# WEST PENNSBORO TOWNSHIP

### WEST PENNSBORO TOWNSHIP PLANNING COMMISSION MEETING

**#2023-12 AAMPA Holdings – Ritner Highway (3485 Ritner Highway, Newville) Subdivision & Land Development Plan**

**Re: Preliminary/Final Land Development and Subdivision Plan for  
AAMPA Holdings – Ritner HWY  
Land Development/Subdivision Plan Review Comments #4  
Project #00004.66**

MRC SUBSURFACE INFILTRATION BASIN 1 PROFILE

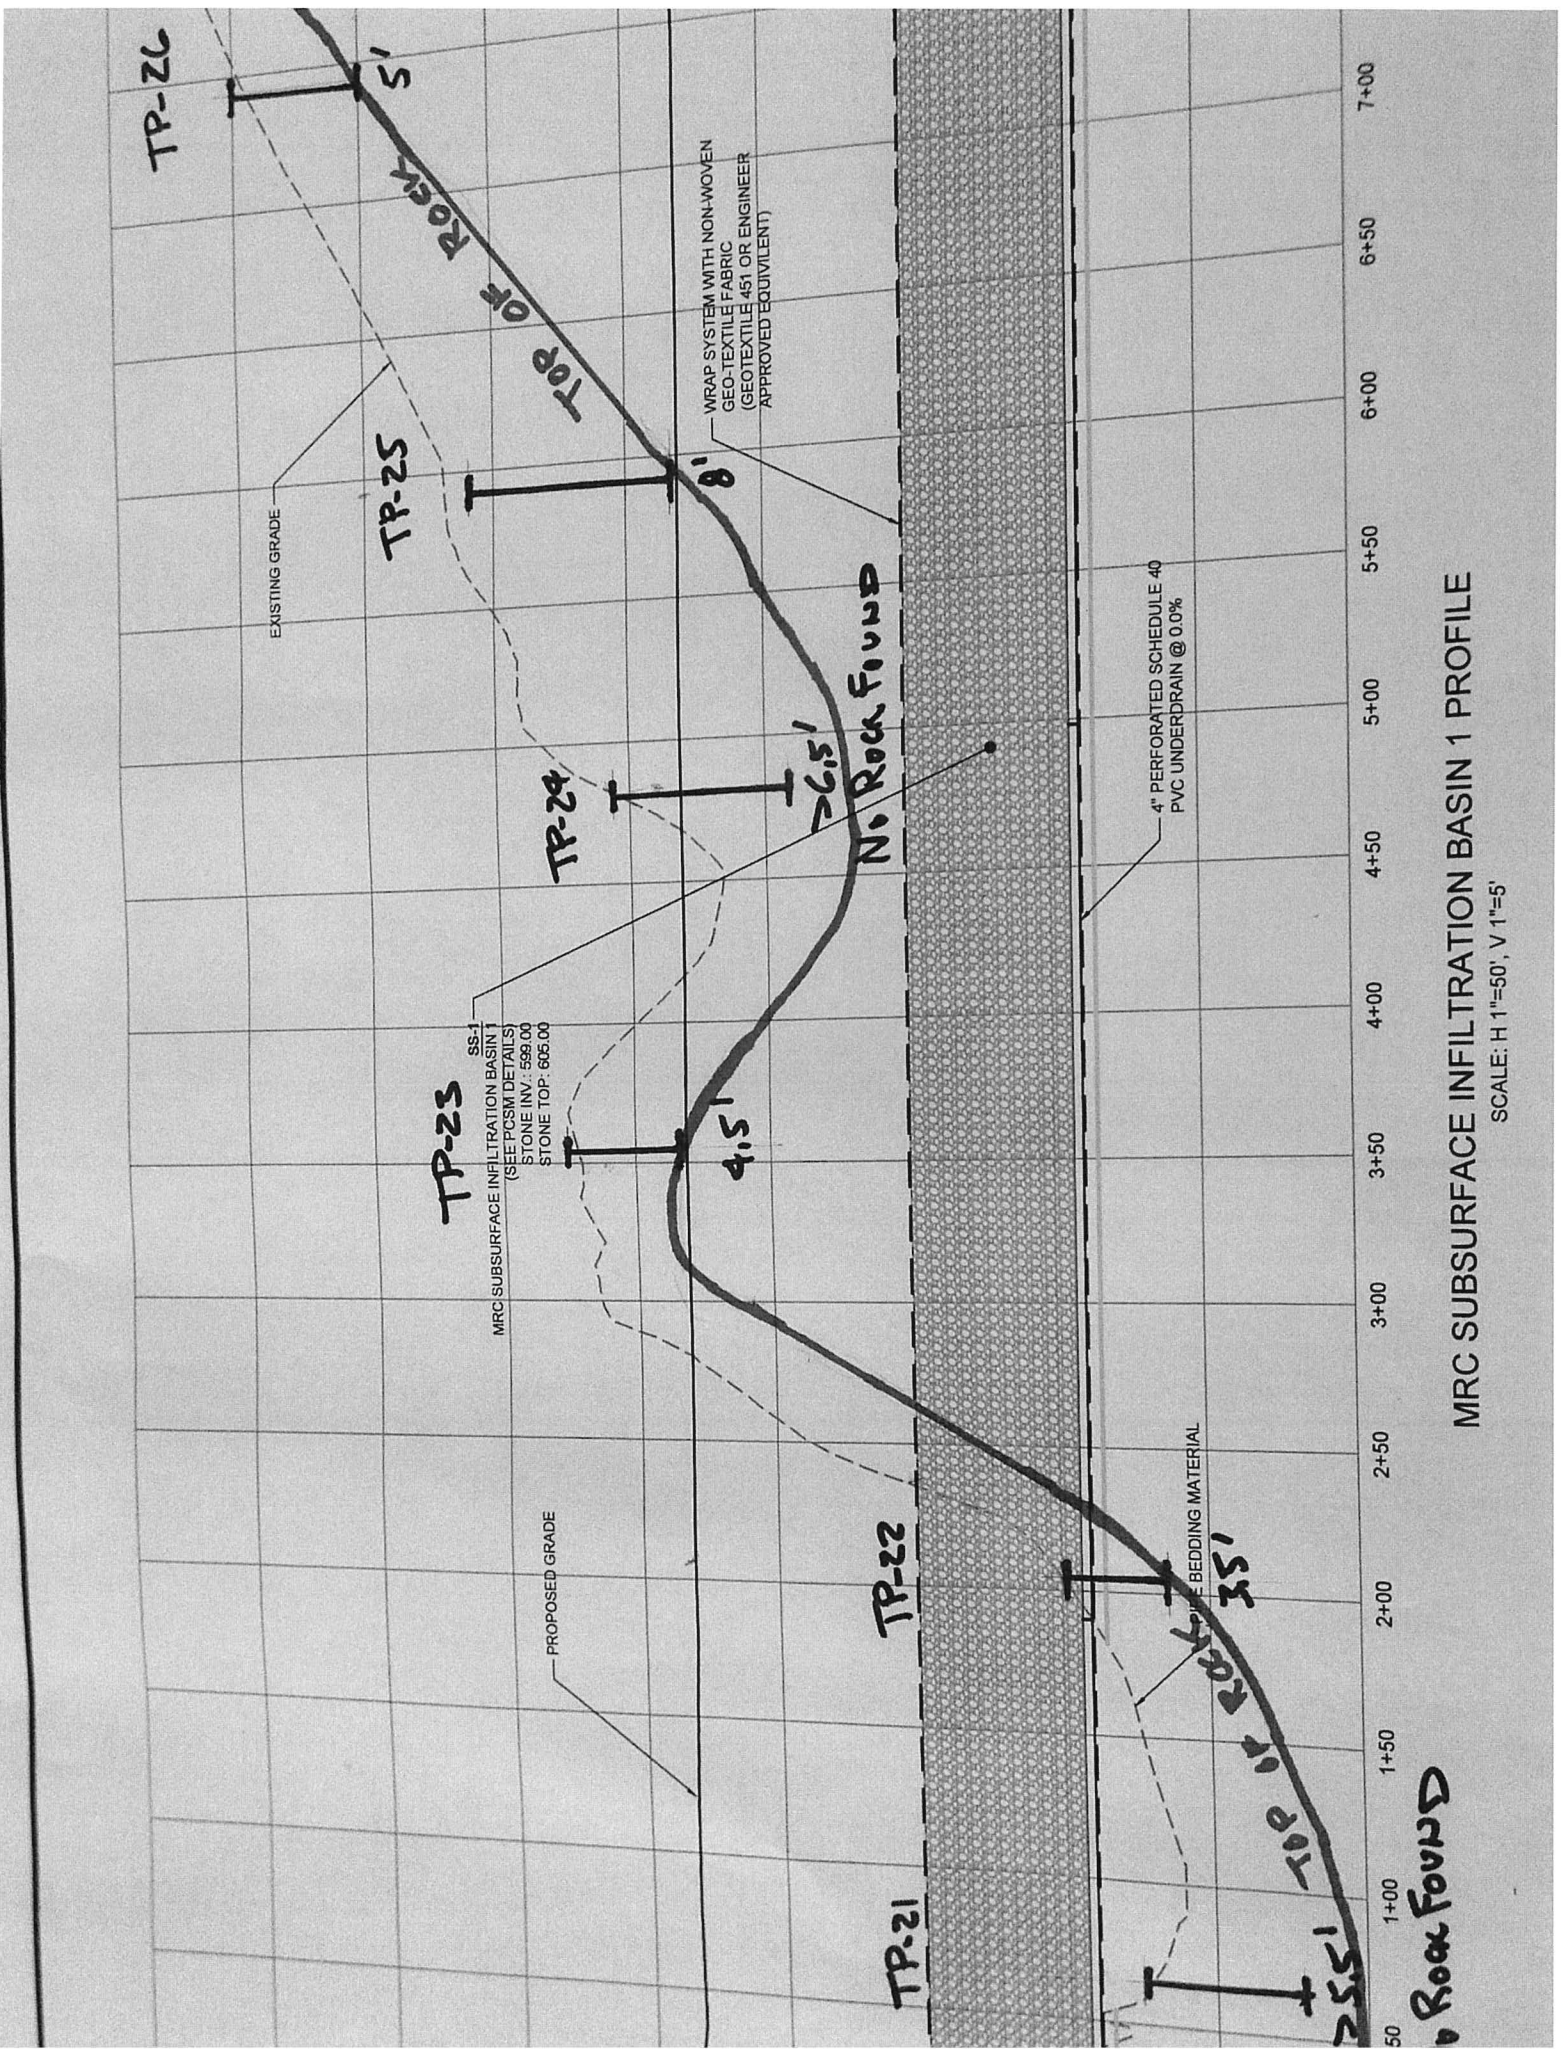
Because the majority of the test pits that have been dug on the site are well above the subsurface basins, the existing plans do not provide adequate data on the suitability of the soil for filtration in these basins. We simply do not know the suitability of filtration at the bottom of these proposed basins. Without suitable filtration rates, during major storm events water will overflow out of the subsurface basins and become surface run off toward Big Spring.

Analysis of the plans of the subsurface infiltration basins and data from the test pits indicate that around 2/3 of the linear feet of the basins are sitting directly on limestone. Basins sitting directly on the limestone bedrock often do not have suitable filtration rates, which increases the possibility of contamination entering the ground water and the creation of sinkholes. Finally, the developer's storm water management report admits that the basins do not adhere to the best management practices on karst geography of a 3:1 ratio of impervious surface to filtration areas.

Ultimately, the use of subsurface infiltration basins is not appropriate to the site given the depth of the basins and the karst topography.
